S16 PLANNING APPLICATION
APPROVED TONG YAN SAN TSUEN OZP NO. S/YL-TYST/14

**Section 16 Planning Application for Proposed Minor Relaxation of
Building Height and Plot Ratio Restrictions
for Permitted Public Housing Development at
Long Bin, Yuen Long
(Application no. A/YL-TYST/1285)**

Reference is made to the captioned Section 16 application received by the Town Planning Board on 27.9.2024 and the comments received from Planning Department dated 15.10.2024, 24.10.2024, 30.10.2024, 31.10.2024, 4.11.2024, 6.11.2024 and 13.11.2024. We submit herewith the table summarizing HD's responses to the comments as well as the replacement pages and illustrative drawings to substantiate the application.

Drawing title
PROPOSED DRAINAGE PLAN
(SHEET 2 OF 3)

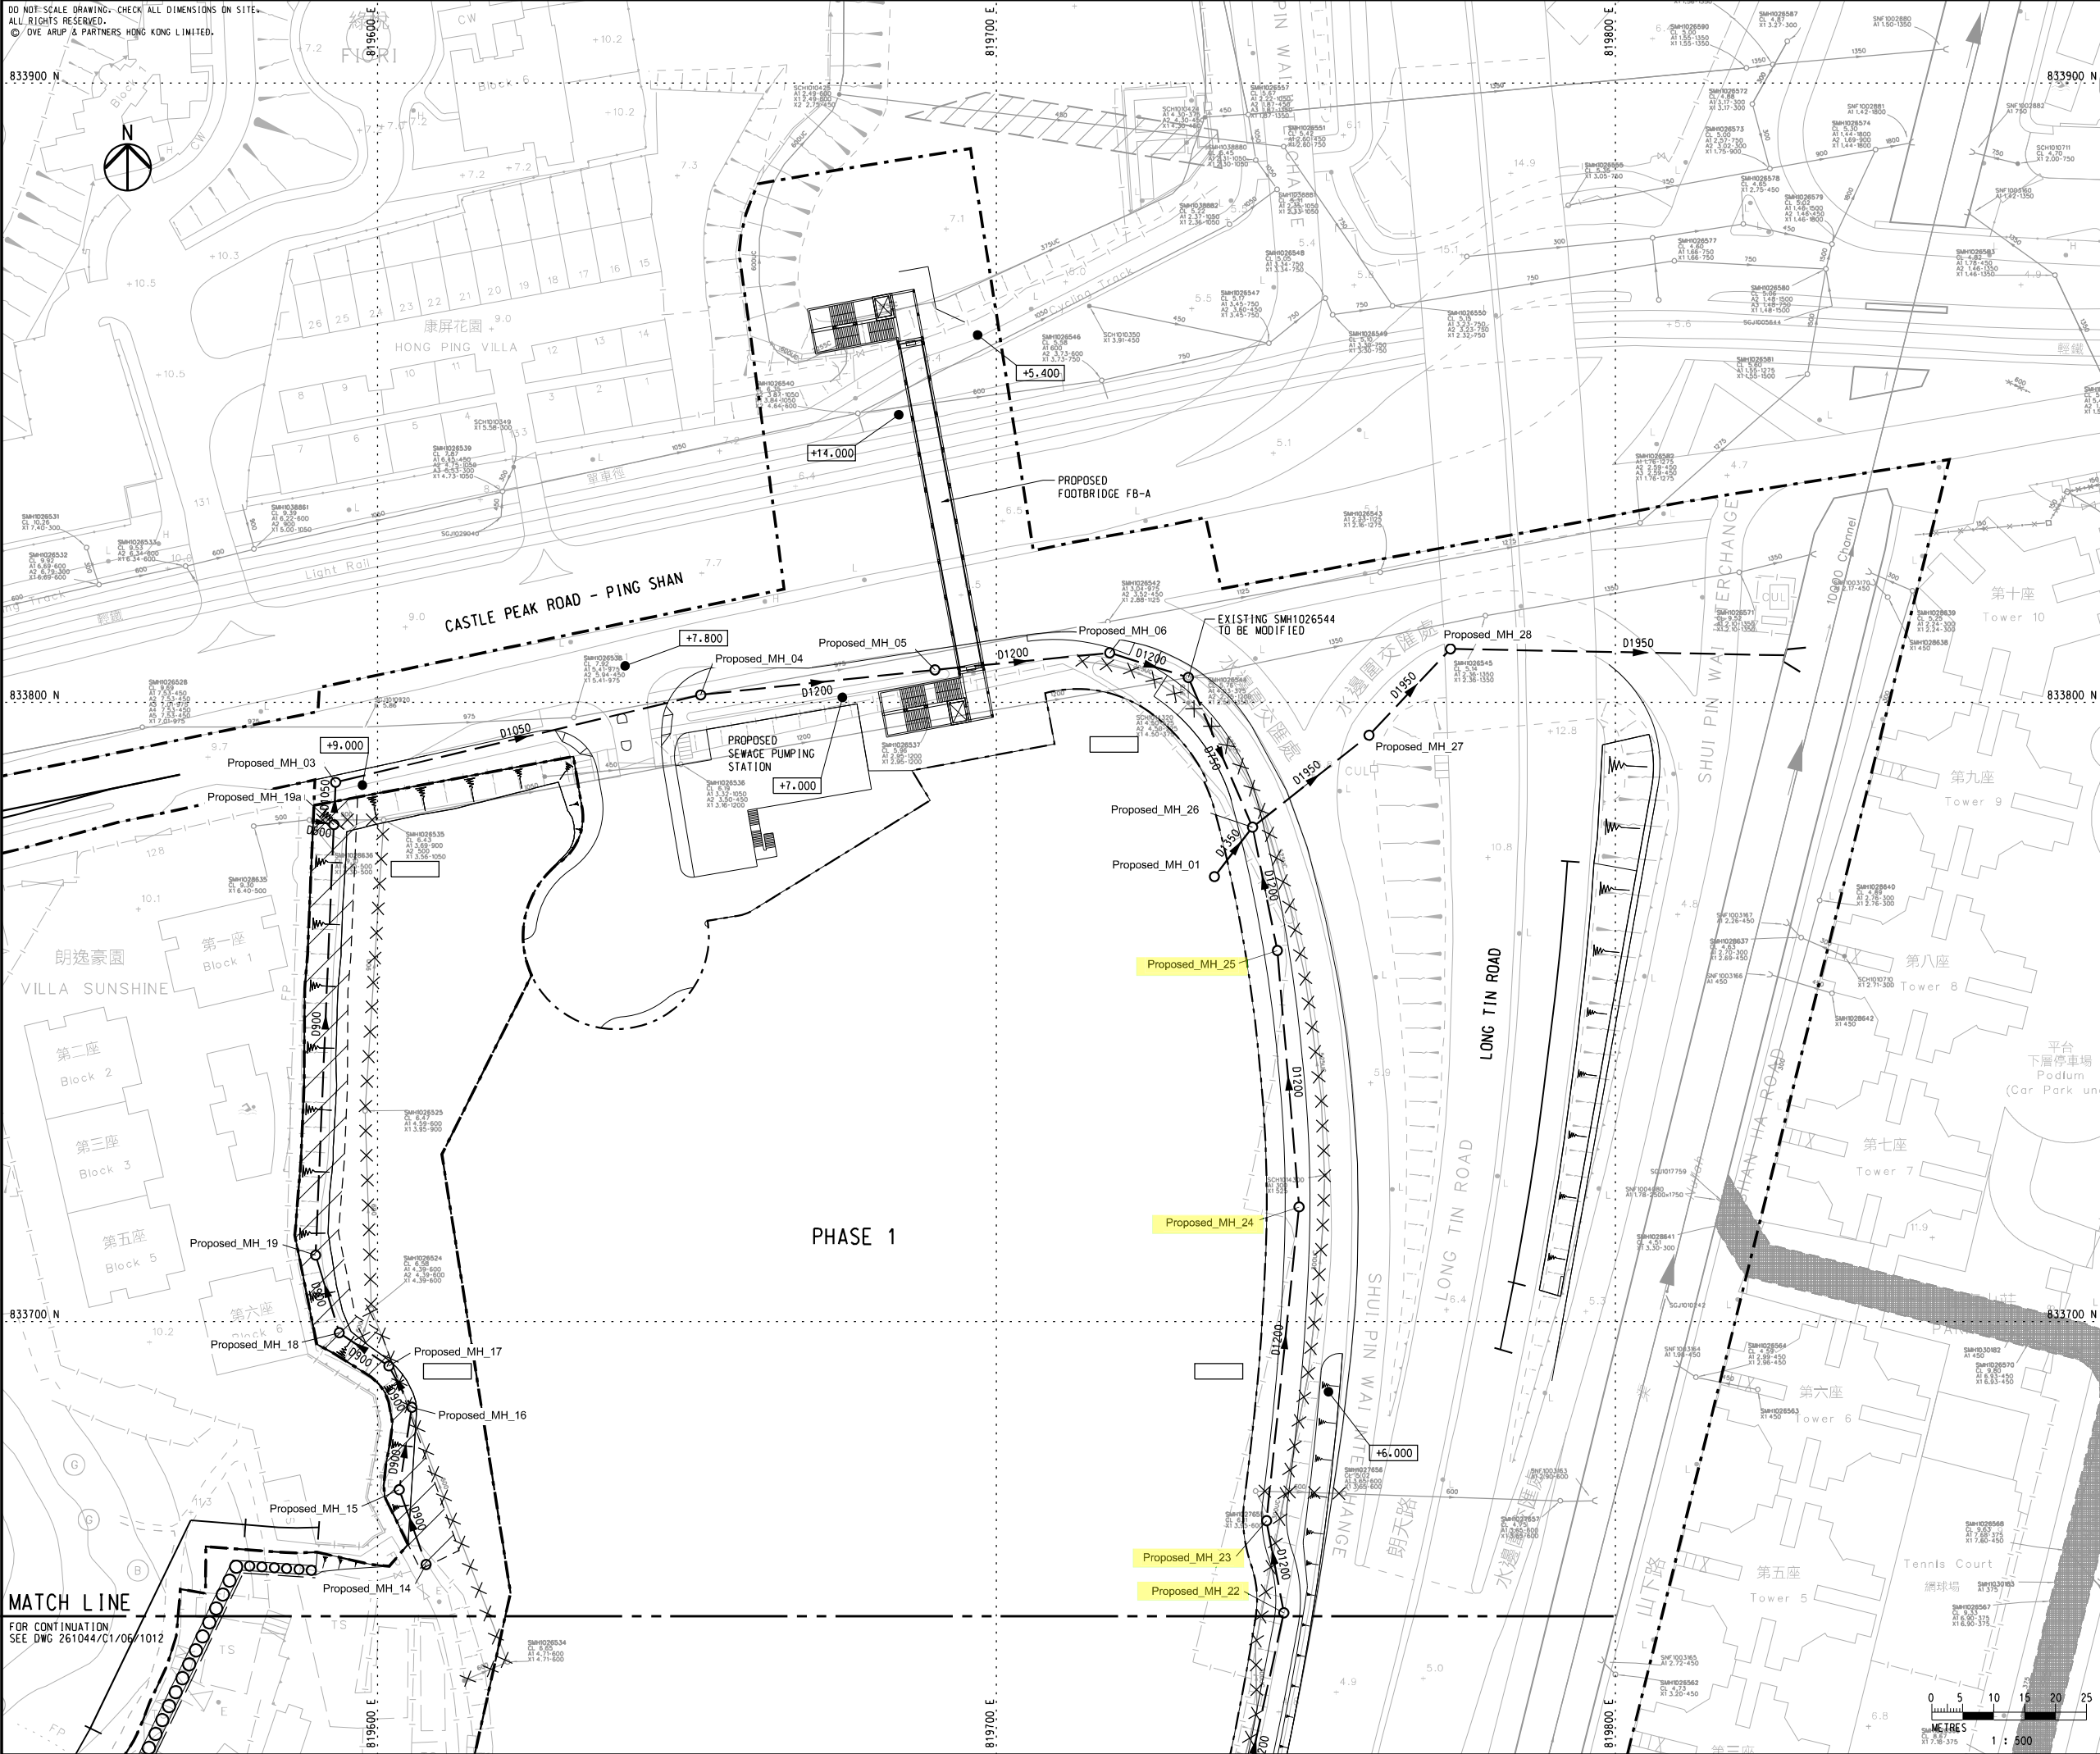
Comments	Responses
3.	<u>Drainage Services Department</u> (30.10.2024)	
	<u>Drainage Impact Assessment (DIA)</u> (a) The design of stormwater drainage system should be in accordance with the latest version of the Stormwater Drainage manual and its Corrigendum including nos. 1/2022, 1/2024 and 2/2024.	<p>The Revised Final DIA by CEDD for the subject Long Bin public housing development was approved in December 2000. Relevant plans are extracted in Attachment 2 which show the proposed stormwater drains to be constructed along Long Tin Road and connected to adjacent Yuen Long Nullah.</p> <p>The current S.16 Application is associated with a slight increase of non-domestic plot ratio from 0.5 to 0.8 for Phases 2 and 3. The proposed change in non-domestic plot ratio had not altered the details, design principles and rationale in CEDD's Revised Final DIA (e.g. catchment plan, 70% paved, proposed drainage connections, pipe size, invert levels, etc.).</p> <p>Therefore, it is considered that the paved area is the <u>same as previous paved area</u> in CEDD's Revised Final DIA and there would be <u>no additional drainage impact</u> to the drainage characteristic of the subject site or incurred to CEDD's Revised Final DIA as a result of the proposed change in non-domestic plot ratio.</p> <p>As climate change scenario of mid-21st century was originally adopted in CEDD's Revised Final DIA, it is considered reasonable to adopt the same scenario for consistency.</p> <p>A summary table of Max. Water Level (extracted from CEDD's Revised Final DIA) is provided below. It could be seen that all manhole locations have ample buffer over the minimum freeboard requirement (i.e. 300mm). The remaining freeboard buffers (e.g. at least 180mm for the manhole (MHA01) below) would sufficiently help cater for the additional</p>

(b) Section 2.1: Climate change scenario of end-21st century with design allowance should be assessed according to Corrigendum No. 1/2022.	
	(c) Annex 2: Please justify the calculation of max. water level under latest design standard is valid. Please also indicate the percentage of the capacity reached for each section of the proposed and existing stormwater pipes for reference. According to Section 9.3 of Stormwater Drainage Manual, please ensure that suitable allowance should be made in the design for the deposition of sediment in stormwater channels and pipes.

<p>The sedimentation for proposed works (i.e. 10% reduction of flow area) has been considered in Appendix D of CEDD’s Revised Final DIA (Attachment 2).</p>	Location	Ground Level (mPD)	Max. water level of 50-year (mPD)	Freeboard (m)	Proposed_MHA01 (D1200)	6.00	5.52	0.48	Proposed_MHA02 (D1200)	6.00	5.49	0.51	Proposed_MHA03 (D1200)	6.00	5.31	0.69	Proposed_MHA04 (D900)	6.00	5.17	0.83	Proposed_MHA05 (D1350)	6.00	5.13	0.87	Proposed_MHA07 (Existing 2xD1350)	6.00	5.02	0.98	Proposed_MH_02 (D1200)	6.00	5.31	0.69	Proposed_MH_20 (D1200)	6.00	5.29	0.71	Proposed_MH_21 (D1200)	6.00	5.23	0.77	Proposed_MH_22 (D1200)	6.00	5.17	0.83	Proposed_MH_23 (D1200)	6.00	5.14	0.86	Proposed_MH_24 (D1200)	6.00	5.07	0.93	Proposed_MH_25 (D1200)	6.00	5.01	0.99
Location	Ground Level (mPD)	Max. water level of 50-year (mPD)	Freeboard (m)																																																							
Proposed_MHA01 (D1200)	6.00	5.52	0.48																																																							
Proposed_MHA02 (D1200)	6.00	5.49	0.51																																																							
Proposed_MHA03 (D1200)	6.00	5.31	0.69																																																							
Proposed_MHA04 (D900)	6.00	5.17	0.83																																																							
Proposed_MHA05 (D1350)	6.00	5.13	0.87																																																							
Proposed_MHA07 (Existing 2xD1350)	6.00	5.02	0.98																																																							
Proposed_MH_02 (D1200)	6.00	5.31	0.69																																																							
Proposed_MH_20 (D1200)	6.00	5.29	0.71																																																							
Proposed_MH_21 (D1200)	6.00	5.23	0.77																																																							
Proposed_MH_22 (D1200)	6.00	5.17	0.83																																																							
Proposed_MH_23 (D1200)	6.00	5.14	0.86																																																							
Proposed_MH_24 (D1200)	6.00	5.07	0.93																																																							
Proposed_MH_25 (D1200)	6.00	5.01	0.99
